A12 Chelmsford to A120 widening scheme

TR010060

DEVELOPMENT CONSENT ORDER CHANGE APPLICATION CONSULTATION

10.13 Consultation Report

Plate 1.1 Updated proposed scheme design, Junction 19 – redesign of north bound on slip road

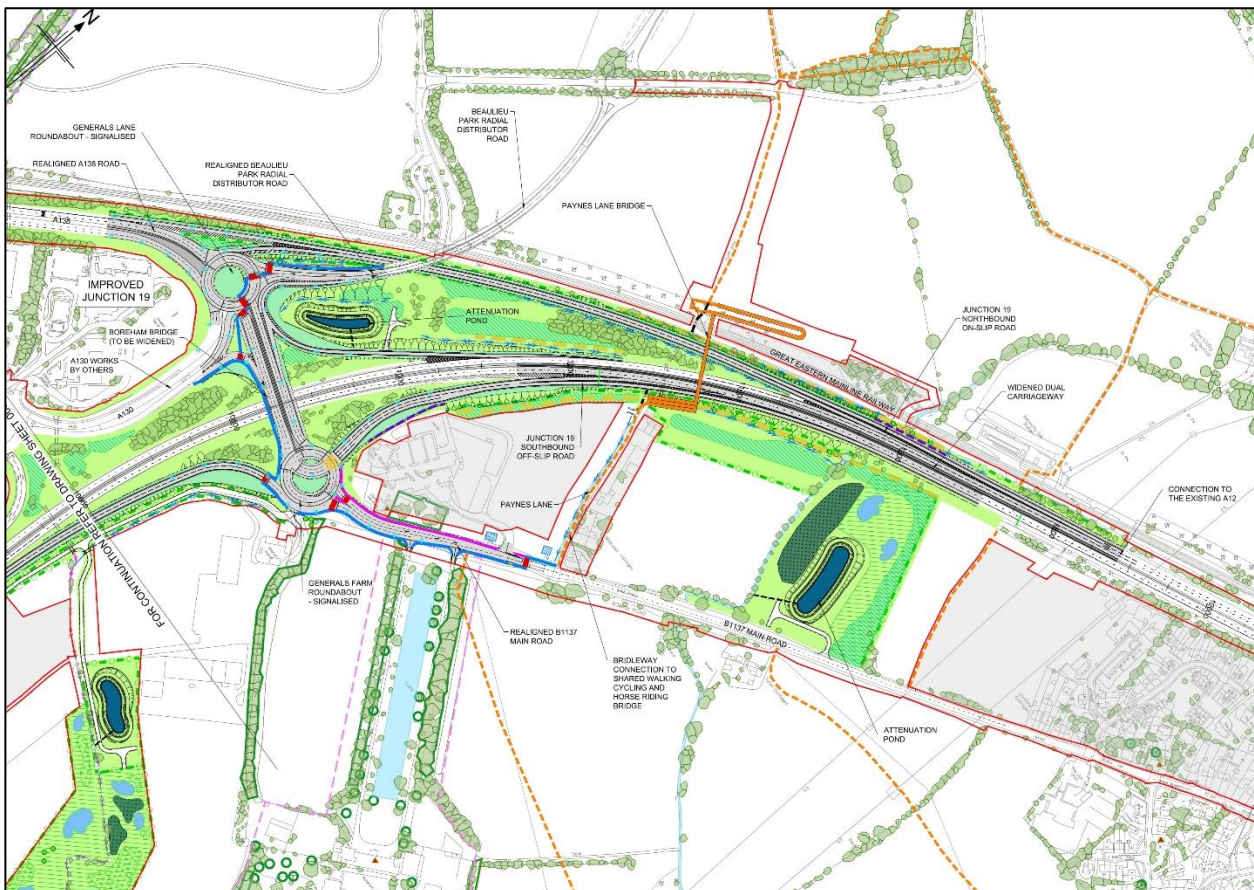
3.2.5 The Applicant received comments from seven respondents regarding the updated design for the junction 19 north bound on slip road.

- Consideration of cyclist's use of roundabout
- DMRB compliance of the updated design
- Impacts to land take at surrounding locations
- Compatibility with local plans for Chelmsford North East Bypass
- Impacts on traffic usage of roundabout

3.2.8 Suggestions made by respondents included to ensure that Essex County Council as the Local Highways Authority accept the updated design of the Junction 19 north bound on slip road.

Plate 1.2 Updated proposed scheme design, Exclusion of Anglian Water pumping station from land proposed for compulsory acquisition at Hatfield Peverel

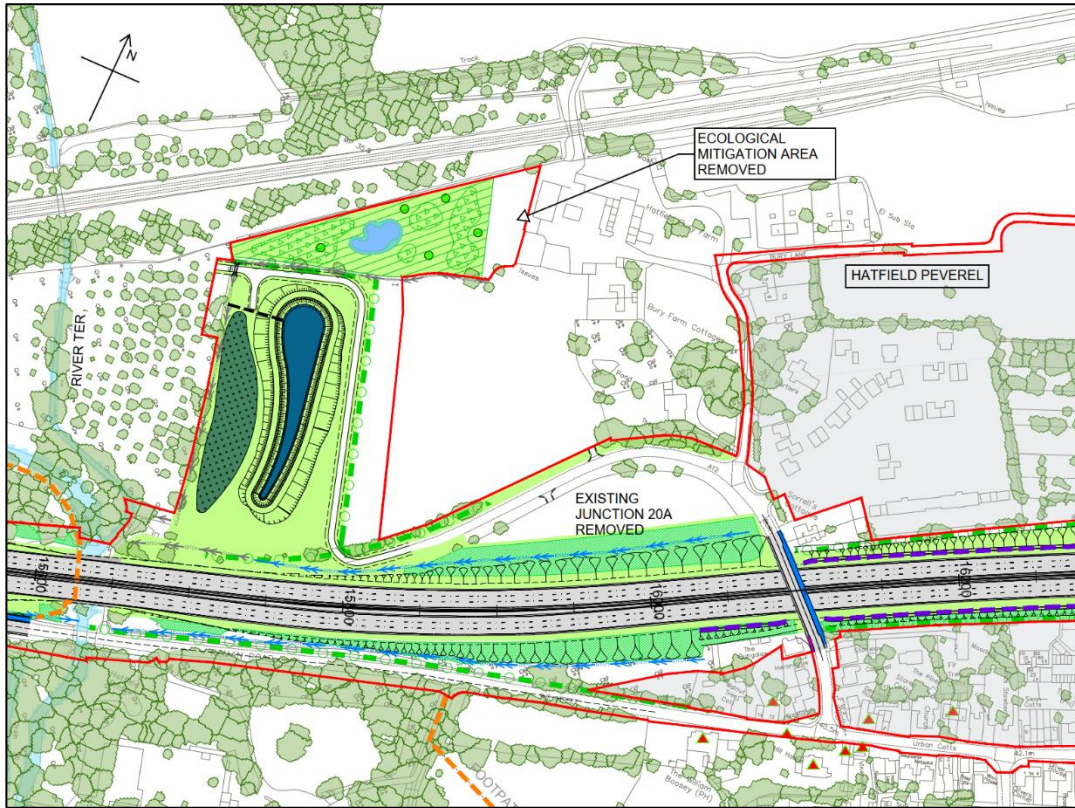
- 3.2.11 The Applicant received comments from five respondents regarding the exclusion of the Anglian Water pumping station from land proposed for compulsory acquisition at Hatfield Peverel. The main themes raised in the comments from Question 2 include the following:

- Environment
 - Walking, cycling and horse riding
- 3.2.12 Key areas of concern identified by respondents included the following:
- Reduction in Biodiversity Net Gain

- Impact to ecological mitigation
 - Clarity that the updated design does not impact the publicly accessible land
- 3.2.13 Suggestions made by respondents included consideration of the local plans regarding ecological mitigation and to ensure that full mitigation is still achievable under the updated proposals.

Plate 1.3 Updated proposed scheme design, Changes to the provision of replacement land at Whetmead and additional consequential changes reflecting change of ownership for open space in the Witham area

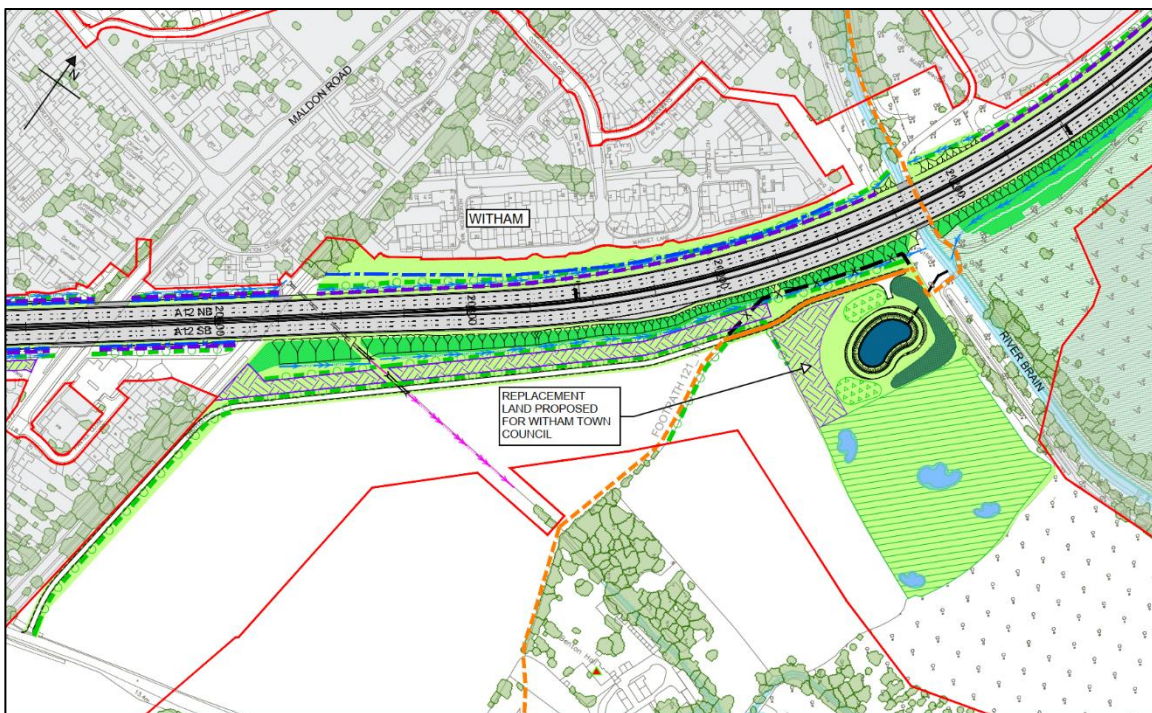
- 3.2.15 This question provided an area to write any free text comments regarding the updated design.
- 3.2.16 The Applicant received comments from six respondents regarding the changes to the provision of replacement land at Whetmead and additional consequential changes reflecting change of ownership for open space in the Witham area. The main themes raised in the comments from Question 3 include the following:

- Walking, cycling and horse riding
 - Design
- 3.2.17 Key areas of concern identified by respondents included the following:
- Further information regarding the public accessibility of replacement land.

- Inclusion of Public Rights of Way route within plans.
- 3.2.18 Suggestions made by respondents included to ensure that Witham Town Council accept the new proposed replacement land, and the use of replacement land to facilitate the Gershwin Boulevard Bridge alternative proposal.

Plate 1.4 Updated proposed scheme design, Drainage works associated with B1023 Kelvedon Road at Inworth

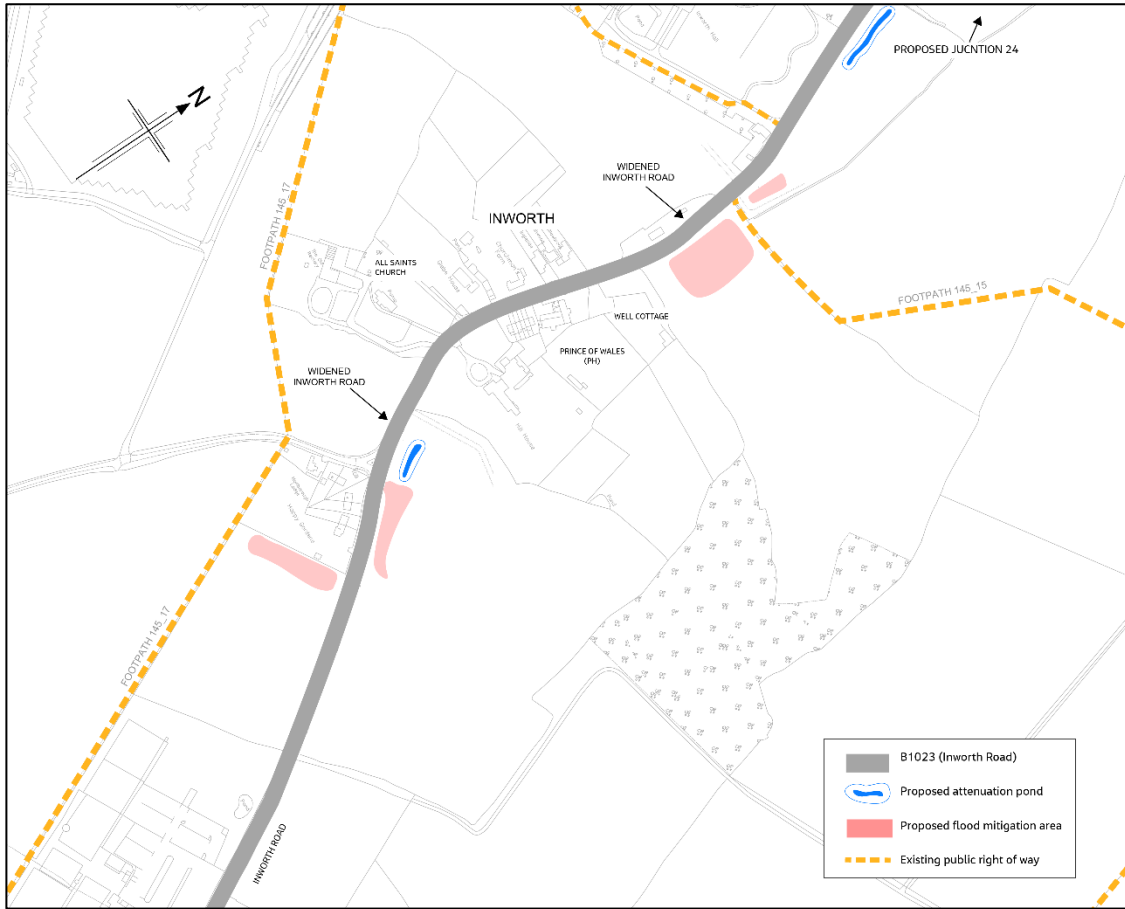
- 3.2.20 This question provided an area to write any free text comments regarding the updated design.
- 3.2.21 The Applicant received comments from five respondents regarding the updated design for the drainage works associated with B1023 Kelvedon Road at

- The reliability of the original information used for original design and the introduction of additional information at this stage
- Clarity that updated design does not negatively impact any Public Rights of Way
- Reduction in drainage mitigation against the unpredictable scenario of climate change
- Clarity regarding Map Books and Technical Notes

3.2.23 Suggestions made by respondents included to ensure Essex County Council as the Lead Local Flood Authority is satisfied with the proposals, and consideration of repairs required to existing damaged drainage chamber.

Plate 1.5 Updated proposed scheme design, Junction 24/Inworth Road B1023 – Removal of the segregated left turn lane

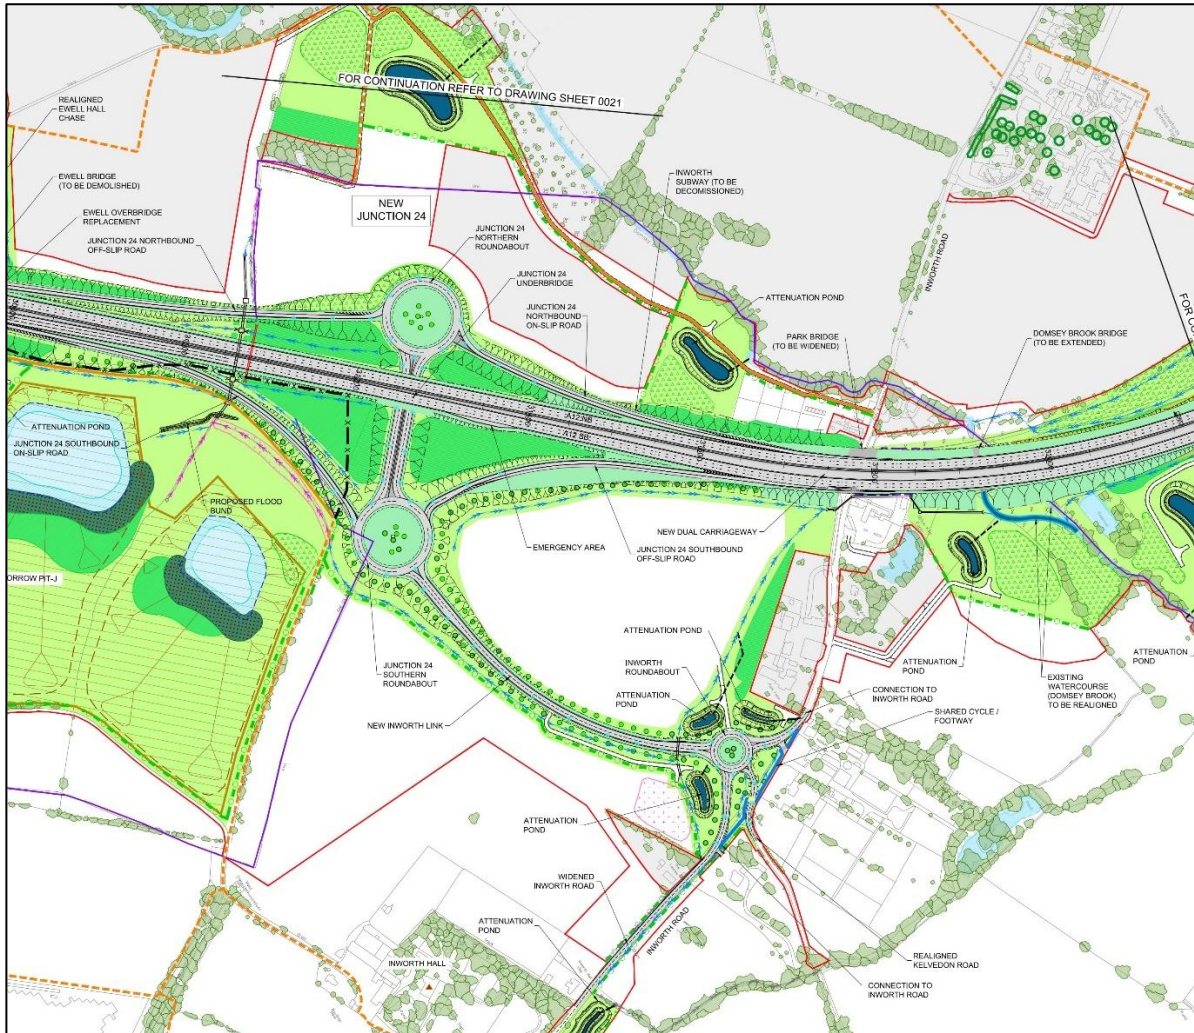
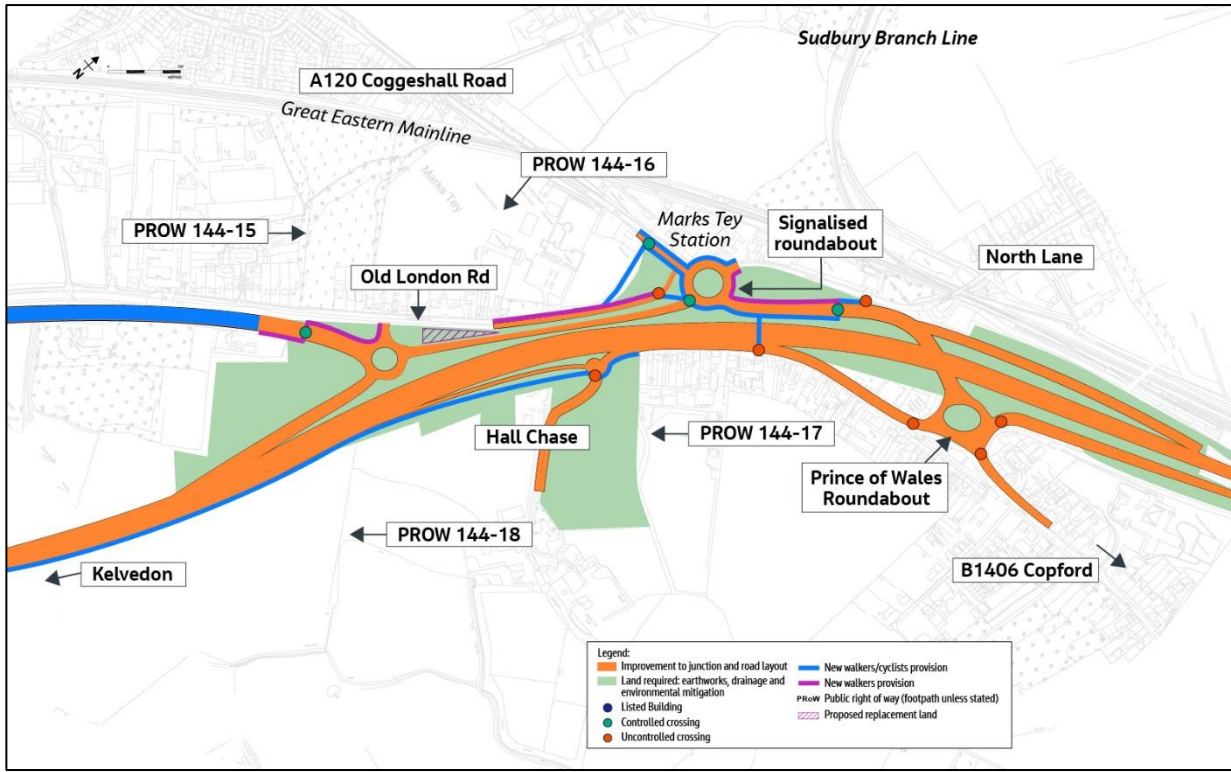
3.2.26 The Applicant received comments from six respondents regarding the removal of the segregated left turn lane at the Junction 24/Inworth Road B1023 roundabout.

- The reliability of the original information used and the introduction of additional information at this stage
- Design standards used for roundabout
- Safety of the updated design
- Proposed design's impact to the local road network and traffic modelling
- Clarity regarding Map Books and Technical Notes

- 3.2.29 Suggestions made by respondents included to ensure that Essex County Council as the Local Highways Authority accept the updated design.
- 3.2.30 All responses to Question 5 and the Applicant's consideration of those responses can be seen in **Annex F**.
